## Technical Specialist Memo - Outstanding Natural Features

North West Rapid Transit

FTAA-2511-1146

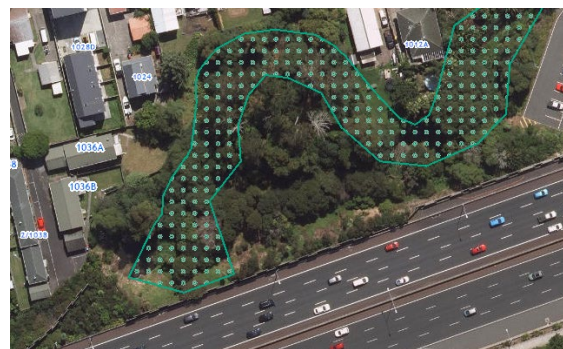
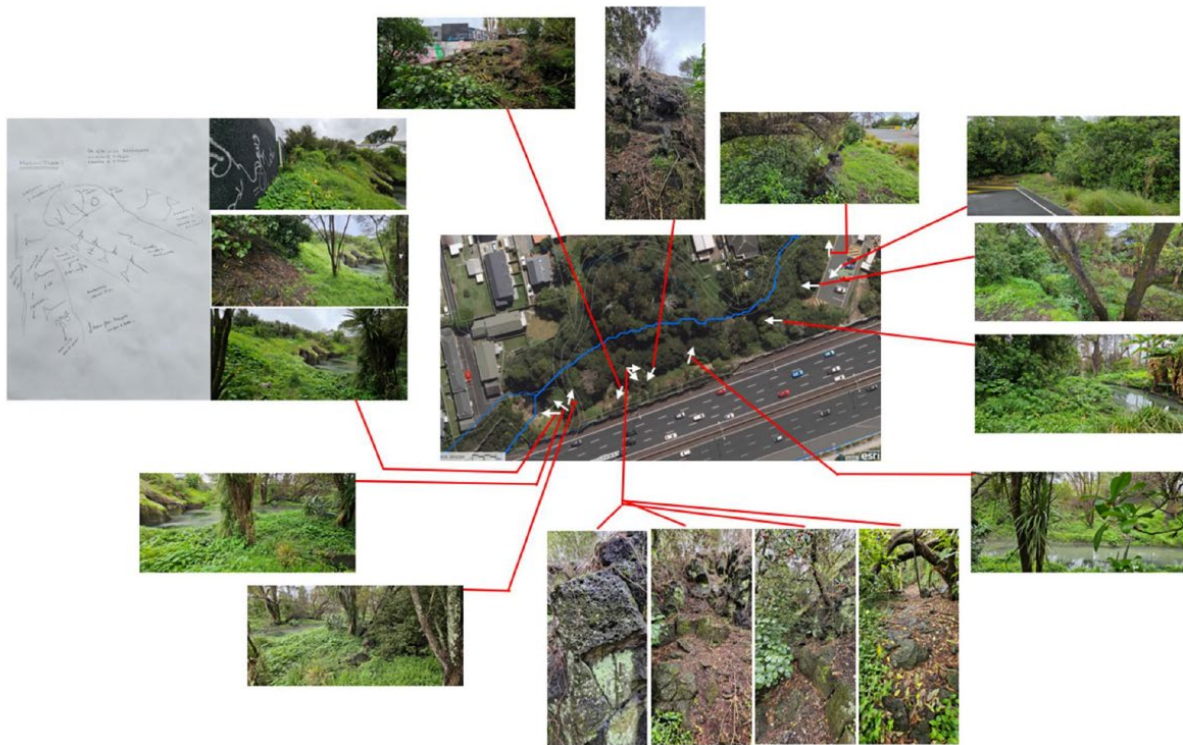
An important point is that the current path of the stream does not follow the path of the mapped ONF Overlay in the area of the proposed bridge (Figure 1). This variation is consistent with the characteristics of this feature, which is protected in the Auckland Unitary Plan / RMA as a dynamic landform; the path of the stream may change, subject to natural physical processes beyond the feature. This is especially relevant as the timeframe for the proposed works is 25 years.

Consideration must be given to the design and location of the bridge piers in order to avoid impacts to the Meola Creek and associated lava flows. The lava flows are exposed extensively along the stretch of the creek where the bridge is being proposed, and the stream runs approximately parallel to the motorway (Figure 1). The effect on the stream depends on the location and size of the bridge piers, which have the potential to destroy both existing lava flow exposures and affect the stream itself.

the ONF Overlay in this area, which speaks to its ability to vary course over time and the importance of protecting the feature for its qualities and values, not merely its mapped extent.

Because of the nature of this feature it is impossible to mitigate or reinstate for damage to either the stream or the associated lava flows. Therefore the works must avoid effects.

A Construction Management Plan (CMP) must be prepared for each stage of work that affects the Waitītiko / Meola Creek and estuary Outstanding Natural Feature (ONF ID 95) and submitted with the relevant Outline Plan. The path of the stream may have changed and continue to change from when the ONF Overlay was enacted. The CMP must demonstrate that works will avoid effects on the Waitītiko / Meola Creek whether or not it follows the shape of the ONF Overlay at the time of works.

The CMP must also demonstrate that works will avoid effects on the basalt lava flows that are the basis on which the Waitītiko / Meola Creek is protected as an Outstanding Natural Feature. The CMP must include how construction methods and design will avoid effects on the Waitītiko / Meola Creek and estuary and associated lava flows. This includes the location and design of the pier(s) to be located at or adjacent to the Waitītiko / Meola Creek and the location and volume of earthworks required to construct the pier(s).
